FINAL ALTERNATIVES ASSESSMENT
OTHER CONTAMINATION SOURCES
INTERIM RESPONSE ACTION
SOUTH TANK FARM PLUME

08/16/90

**COMMENTS AND RESPONSES ON THE
DRAFT FINAL ALTERNATIVES ASSESSMENT
OTHER CONTAMINATION SOURCES
INTERIM RESPONSE ACTION
SOUTH TANK FARM PLUME**

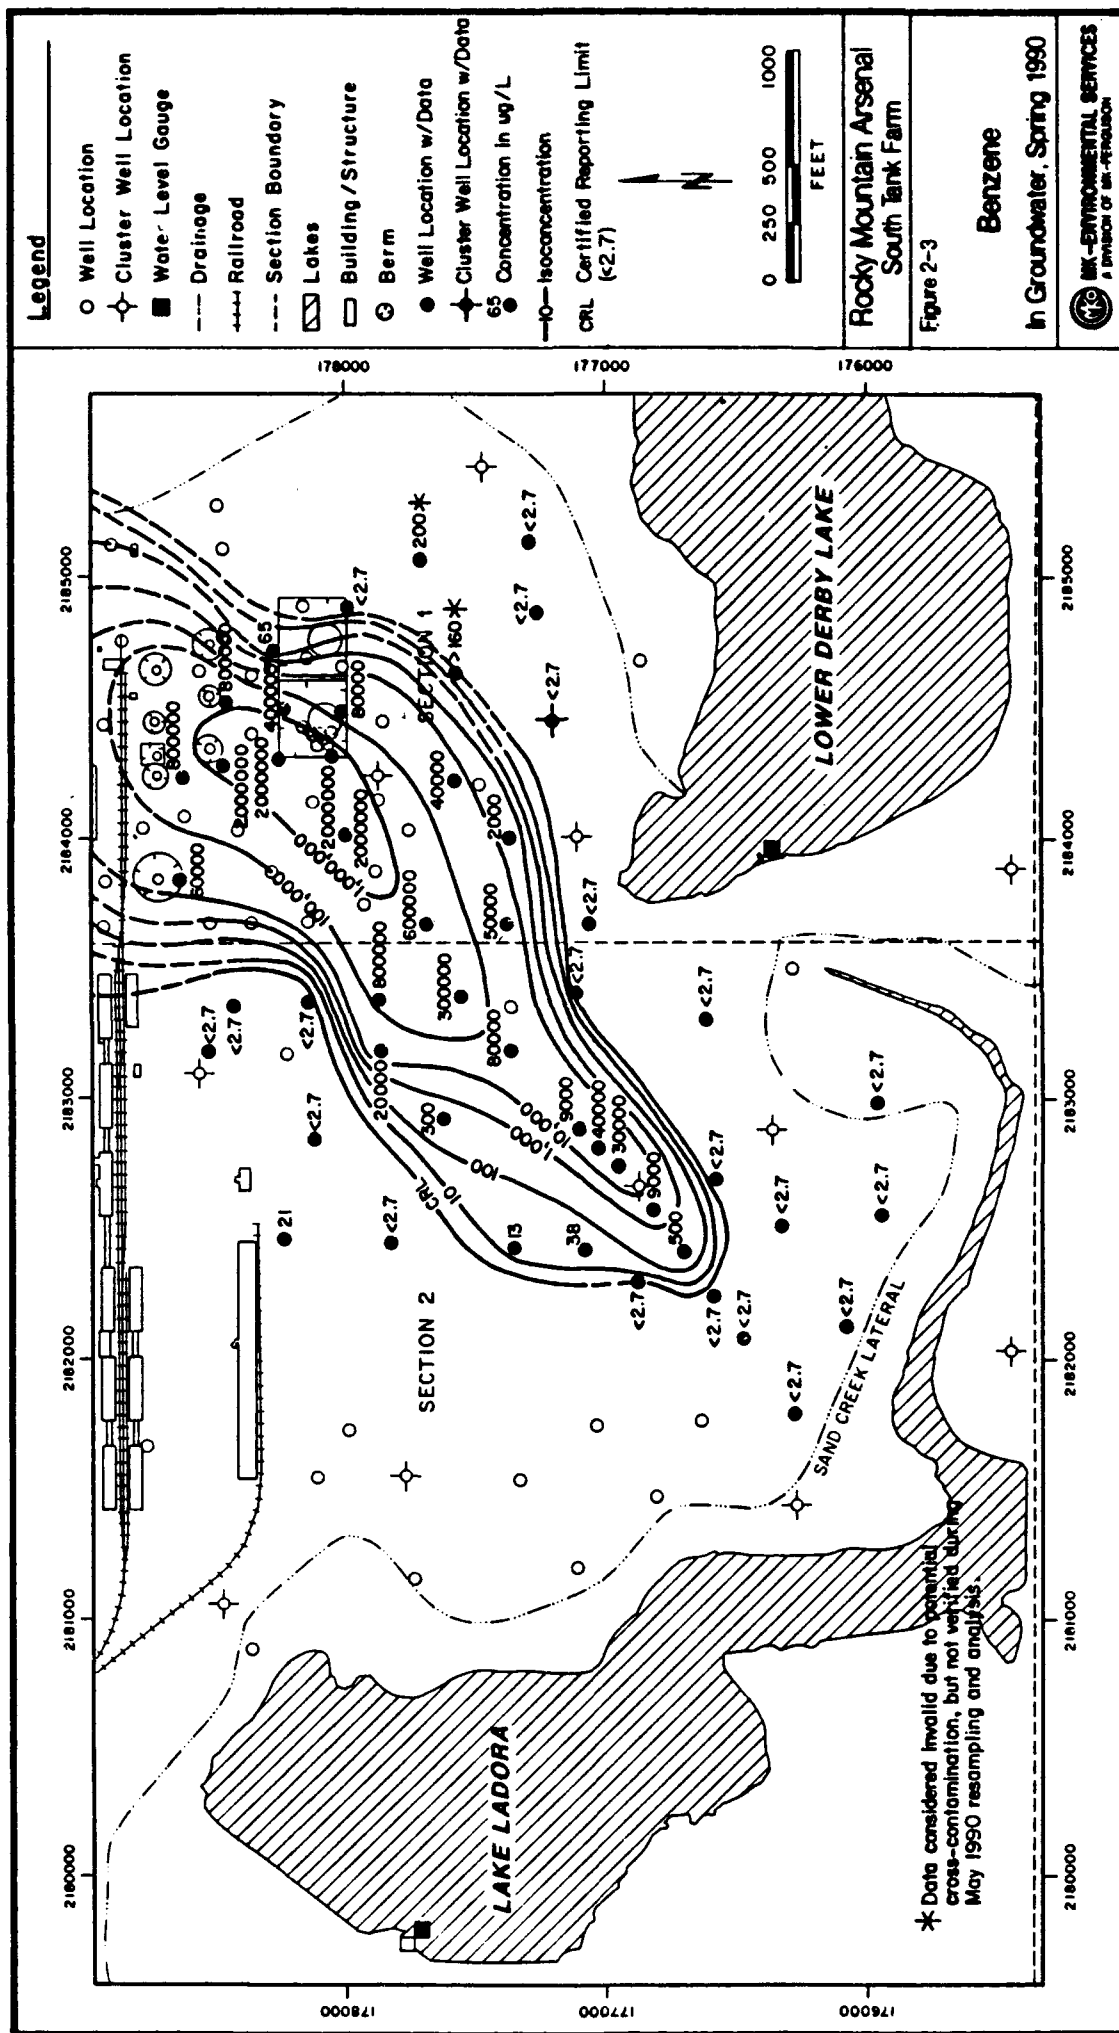
Although DCPD does appear to be distributed over a wider area than benzene in the southeastern component of flow in the Section 1 STFP, DCPD alone does not define the leading edge of the plume. The farthest downgradient well in which DCPD was detected (Well 01587 at a spring 1990 concentration of 69 ug/l) also had a benzene concentration of 2,000 ug/l; therefore, both contaminants define the leading edge of the plume towards Lower Derby Lake. The text should be modified accordingly.

The STFP may be divided into two components: the south-southeastern lobe which includes the region south of Tank 464A and east of the plane between Tank 464A and cluster well 01050; and the southwestern lobe in the area south and west of Tank 464A. The two flowpaths may be more clearly

visualized if one foot contour intervals are shown for the range 5240 to 5245 feet on the water Table Contour Map (Figure 2-2).

The groundwater flow in the vicinity of Well 01587 is sharply deflected to the southwest, around the Lower Derby Lake spillway embankment. The influence of the groundwater flow direction on contaminant distribution near this well is shown by the indented/deflected area of the benzene plume northwest of Lower Derby Lake (Figure 2-3). Contaminant migration for this portion of the plume goes in the direction of Lake Ladora and not towards Lower Derby Lake.
